# WESTERN RESOURCE Adequacy Program

September 12, 2024

BPMs 102, 103, 106, 202 Endorsement Consideration

**Sharing Calculation**

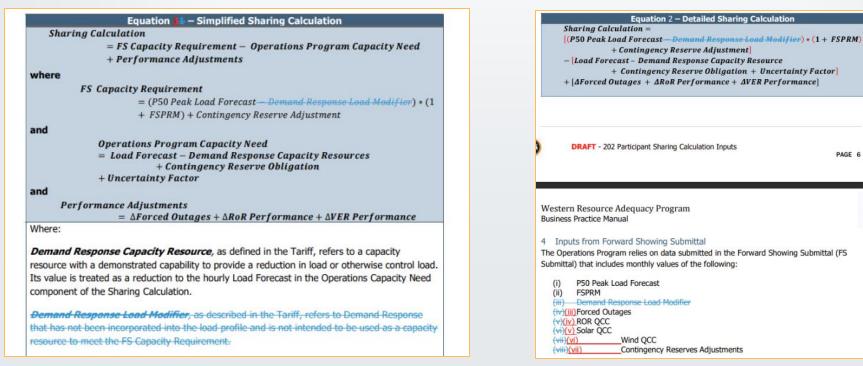
References to Demand Response Load Modifier in sections 3 & 4 were removed to align with BPM 103 and NTFP
